#### CMS5 – MW4 CHANGES

### CMS5 – BB CHANGES

#### CMS5 – DC CHANGES

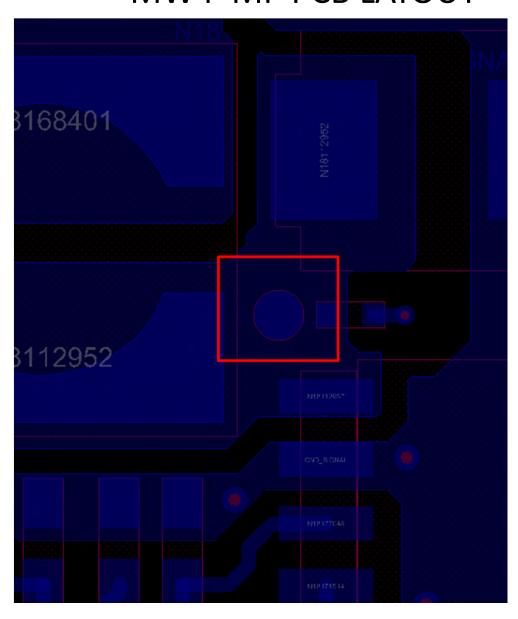
#### 2. Newly Added Test point (TP39) in MP Revision

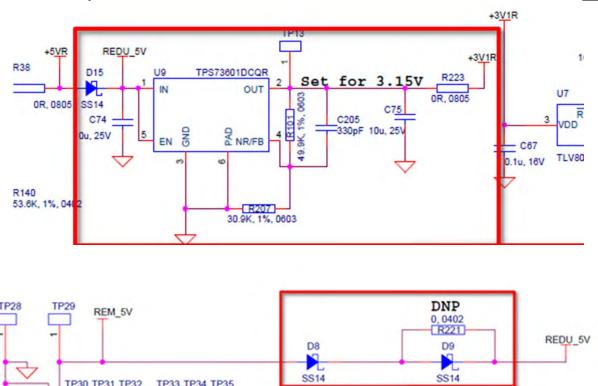
### 4. Main switching power supply reconfigured to 5V (from 3.15V)

## 5. LDO - NCV1117STAT3G replaced with new part TPS73601DCQR and configured for 3.15V (from 5V). Now the LDO can be power either from 5V Switcher or 5V\_STBY

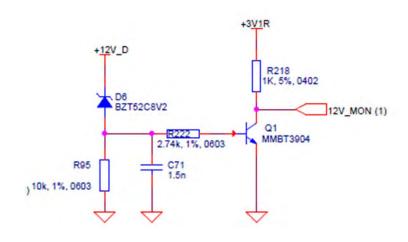
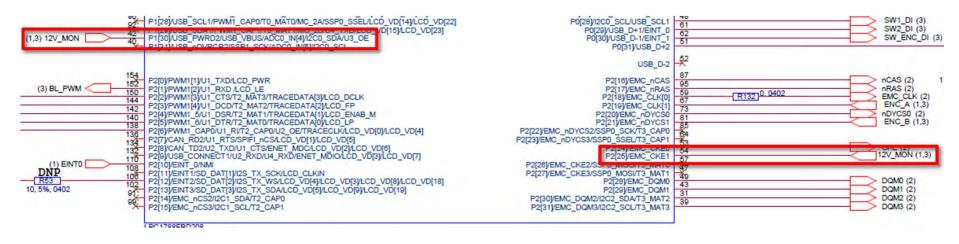
# 6. Battery analog voltage measurement replaced with a interrupt circuit to switch to low power mode when 12V is turned of during sleep mode

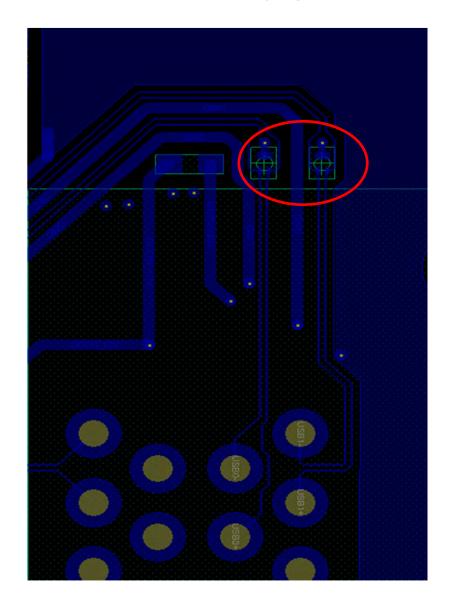
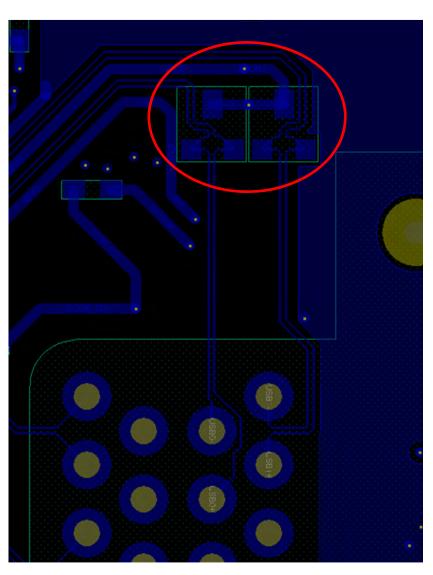
1. D1,D2,D7 &D8 (SOT-883) are Replaced with SOT 23-3 Package.

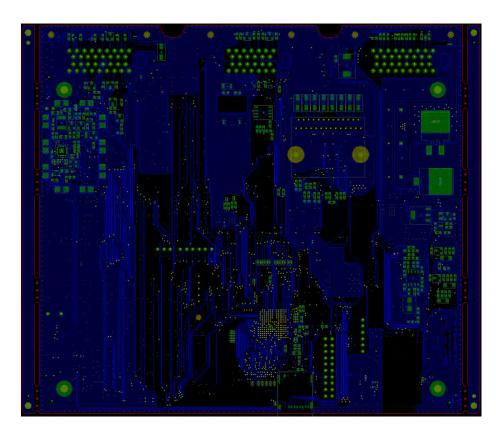
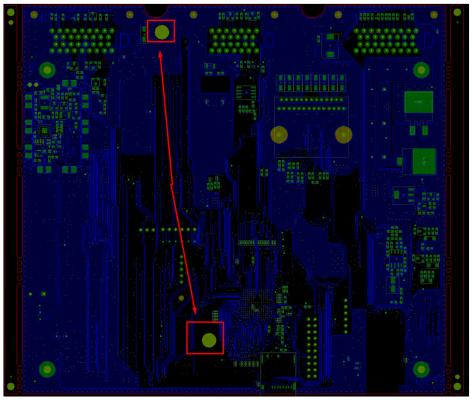
7. Locating Holes added for Assembly Purpose.

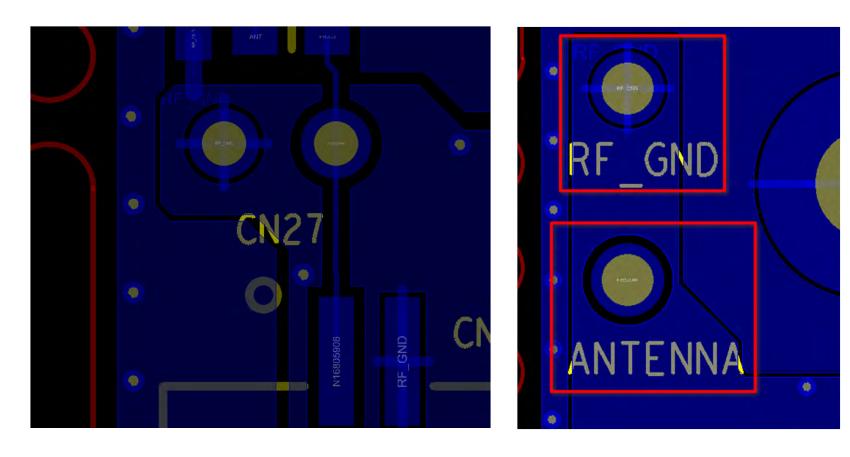
8. Silk Screen Added for Antenna Pins both top and bottom side(Top Side).

CN17 & CN20 Is removed from Schematic CN27 Is rotated by 90 moved away from L5 to avoid Selective Soldering issue

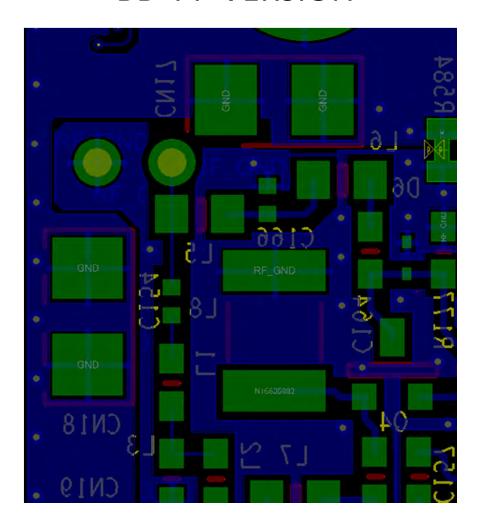
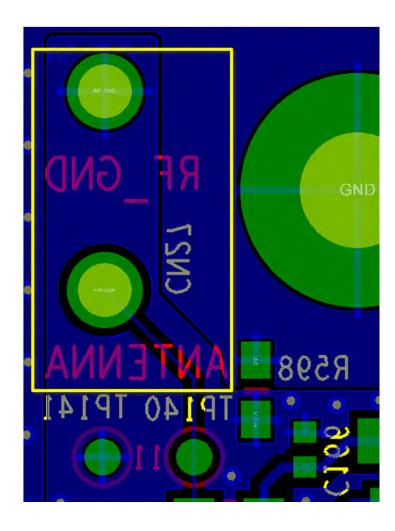
8. Silk Screen Added for Antenna Pins both top and bottom side(Bottom side).

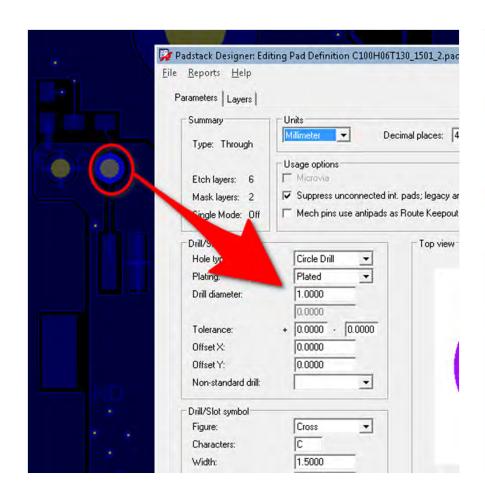
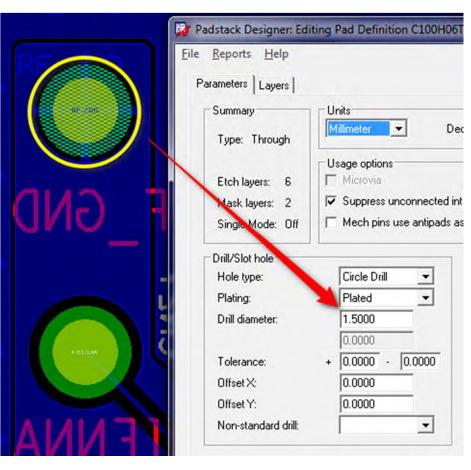
### 9. Through hole size of the Antenna Pigtail is increased from 1mm to 1.5mm

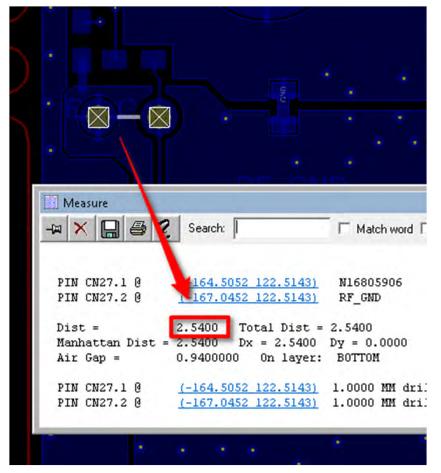
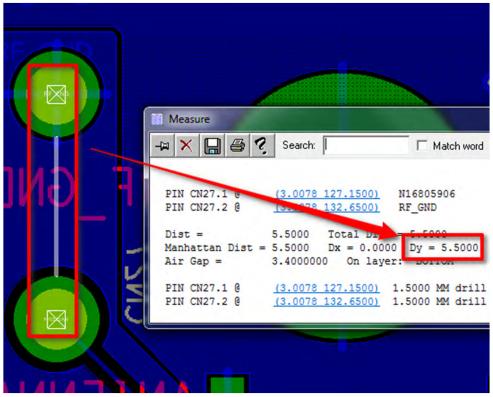
## 10. Pitch oh through hole Antenna Pigtail is increased from 2.54mm to 5.5 mm

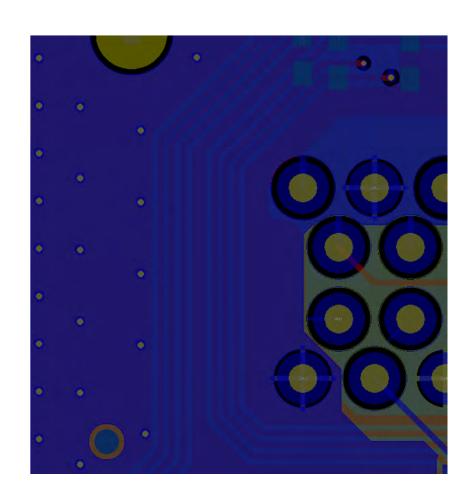
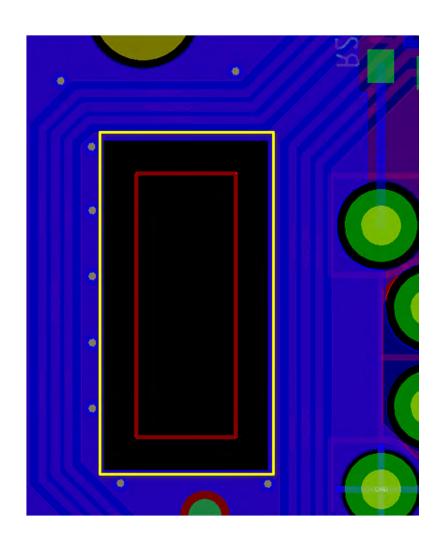
## 12. PCB slot is Introduced for Antenna Pig tail BB PP VERSION BB MP VERSION

#### 13. Schematic Changes (BOM Change).

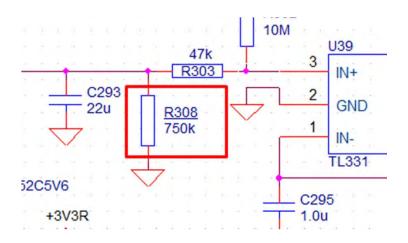
Power down timing resistor changed to 750Kohm

#### 14. Schematic Changes (BOM Change).

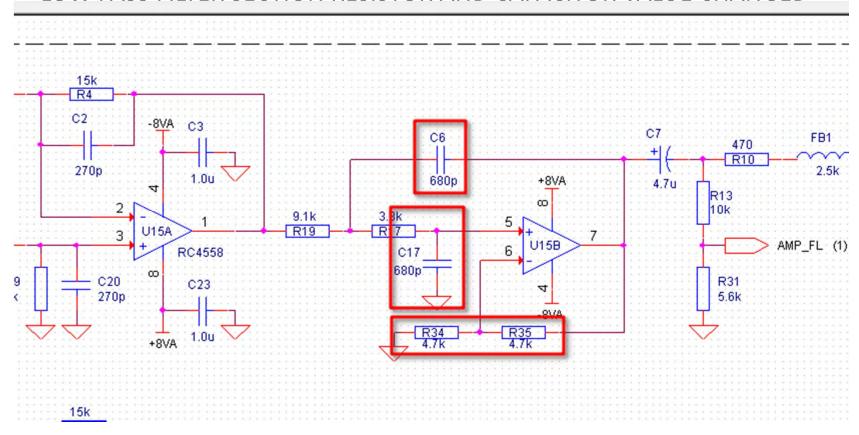
#### LOW PASS FILTER SECTION RESISTOR AND CAPACITOR VALUE CHANGED

Resistors (R34,R35,R70, R71,R100, R101,R122, R123,R36, R37,R72, R73,R102, R103,R434, R435)changed from(5.6K&3K) to 4.7K Capacitors (C6, C17,C30,C41,C53, C65,C73, C79,C8, C21,C33, C43,C57, C66,C368, C410) changed from (820P&470P) to 680P

### 15. Schematic Changes. AM/FM/WB TUNER

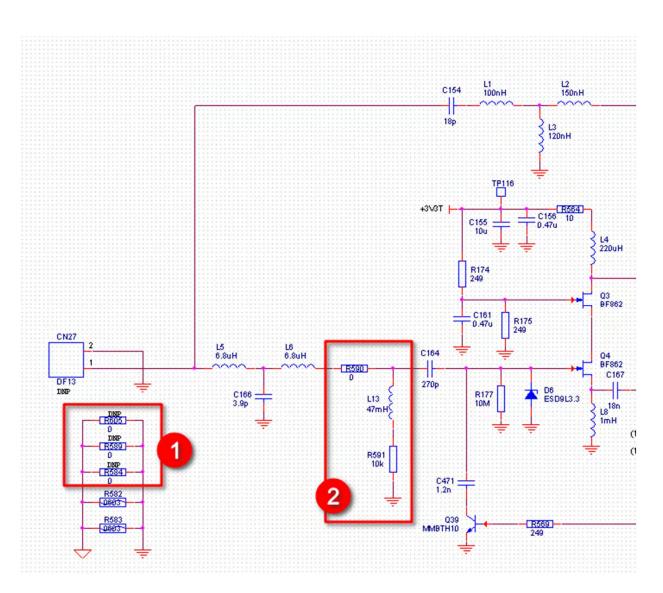
- 1. 0 Ohm resistor are newly added (R584,R589,R605).
- 2. Main strap circuit added newly.
- 3. SMD connector CN20 is removed from the design
- 4. R584 Resistor direct short removed.
- 5. R577 &R578 is removed from the design.
- 6. Sheild clip CN17 is removed from the design.

### 17. Schematic Changes. USB POWER SWITCHES

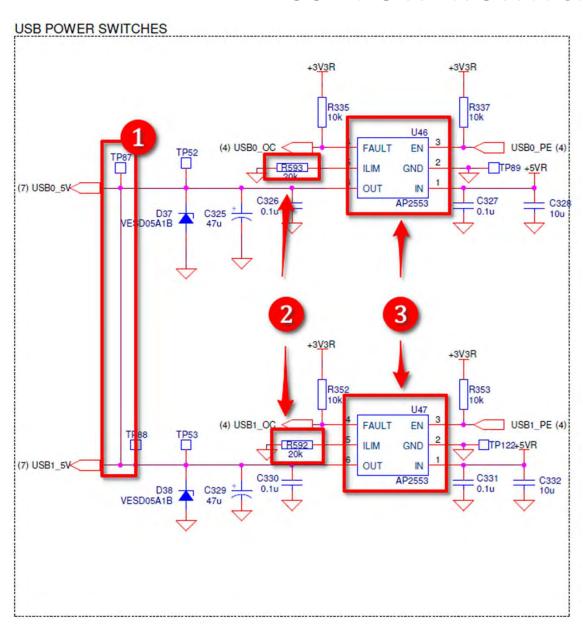
- Both USB Supplies Shorted.
- 2. R593 & R592 is newly added
- 3. U46 & U47 Part is changed from AP2191 To AP2553.

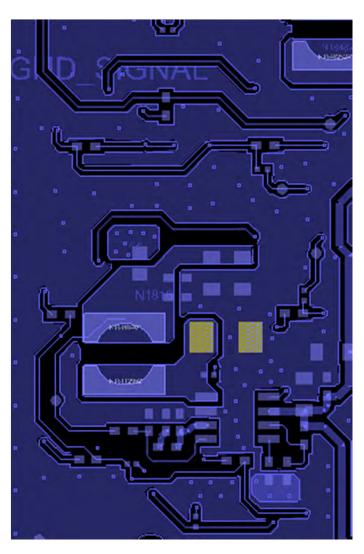
1. 4 Series resistors added accords to TOP switch LEDs to reduce the Current and brightness. (Resistor Values to be finalized to

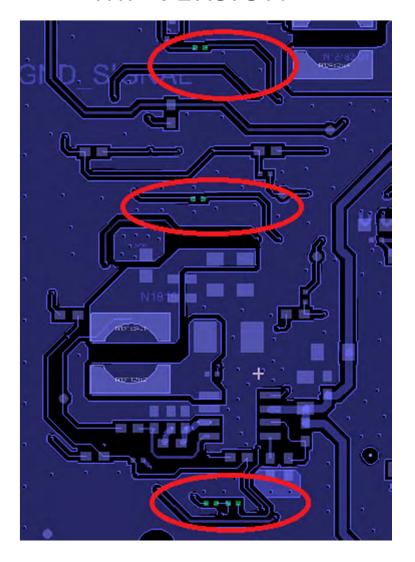
Test-point added at switching Node of 3V3 Power Supply. (No copper Change)

Diode and LED Silk screen modified (No copper Change)

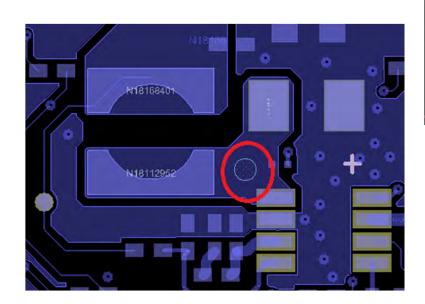
Rev No Updated (No copper Change)

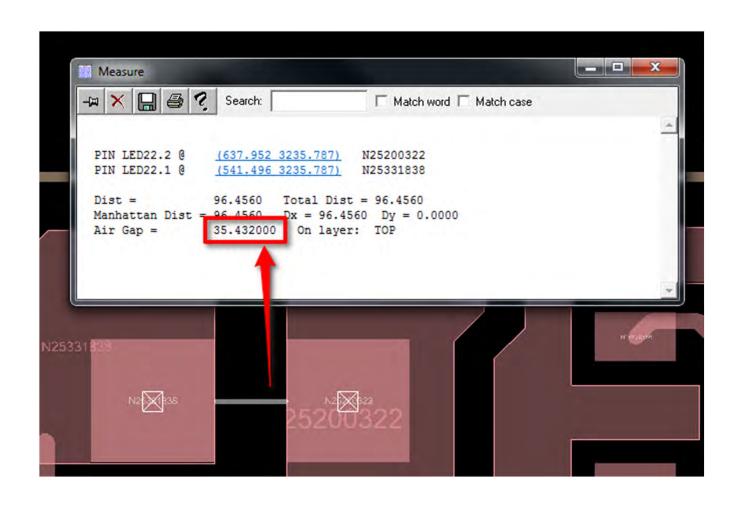
#### LED foot print updated to accommodate various footprints

#### Panel changed to have V-cut for side trips as per Skypine request
